# UNITED STATES PATENT AND TRADEMARK OFFICE

APPLICATION NO.	FILING DATE	FIRST NAMED INVENTOR	ATTORNEY DOCKET NO.	CONFIRMATION NO.
09/800,006	03/06/2001	James C. Rush	STE01 P-1086	5256

## Office Action Summary

## DETAILED ACTION

STRUCTURAL FRAMEWORK AND CONNECTOR JOINT THEREFOR

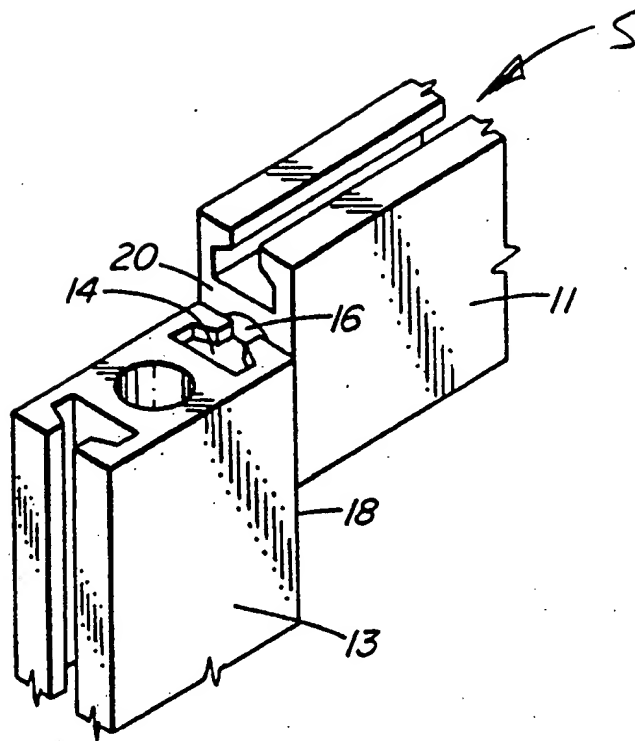
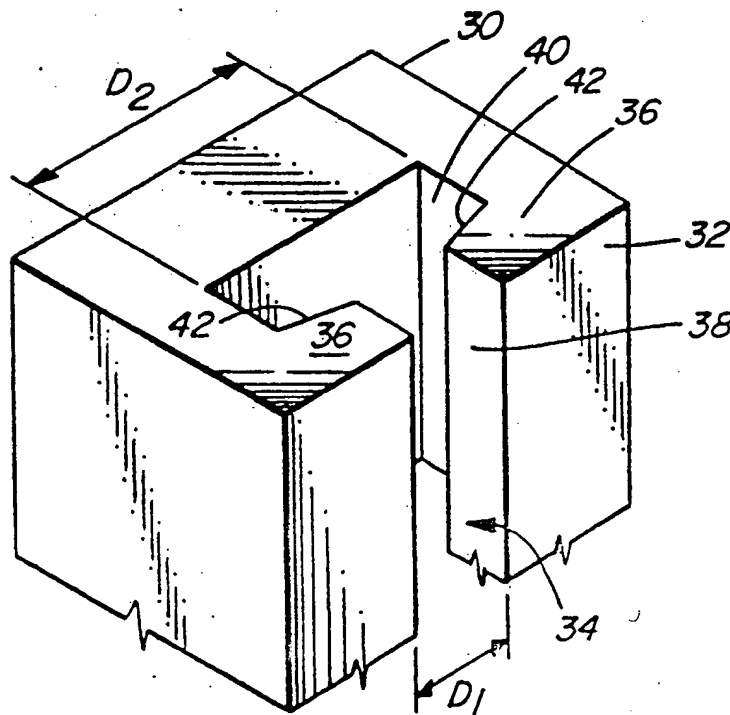
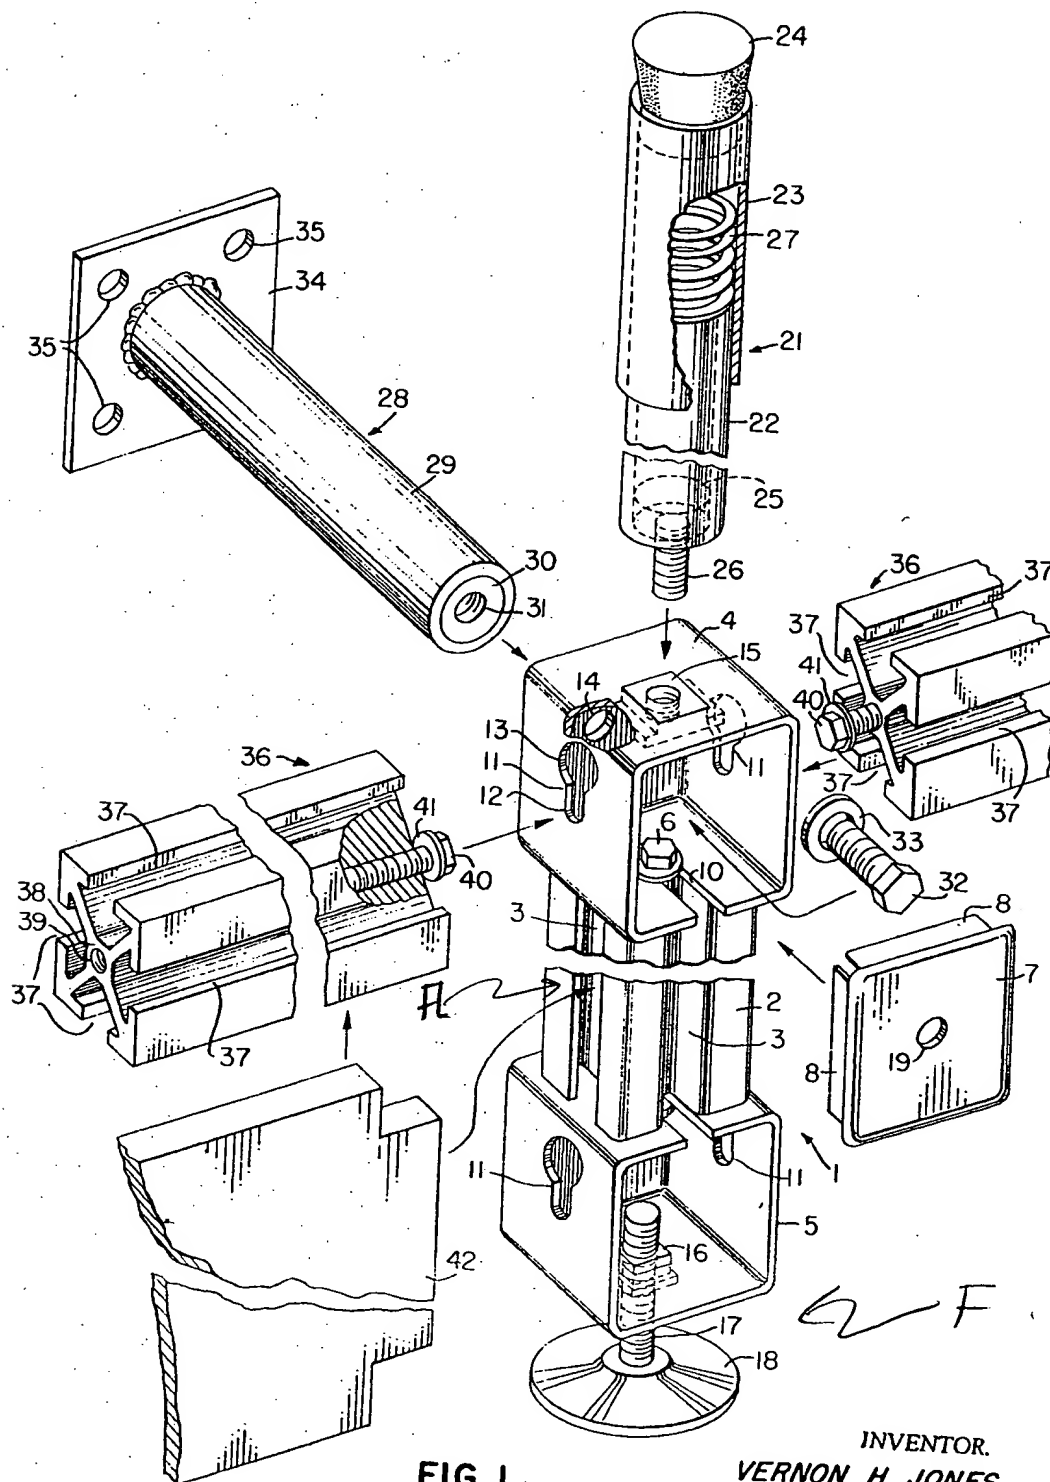
3. Claims 1 and 27 stand rejected under 35 U.S.C. 102(b) as being anticipated by US Patent #3,513,606 to JONES. JONES discloses a furniture system including a plurality of overhead

beams (36) having an upper surface including a single horizontal slot (37), a plurality of vertical posts (2) having outwardly extending flanges (FL) and an end face with a vertical central slot (3), and a plurality of connectors (4,40). The slots (3) are generally T-shaped with an enlarged interior track portion (IT) and a reduced neck portion (N) and the connectors (4,40) are shaped to be received within the slots (3). The overhead beams (36) have slots (37) in a lowermost face thereof, see attachment. Regarding claim 27, the vertical posts (20) include hollow bases (5) with adjustable leveling telescoping feet (F), see attachment.
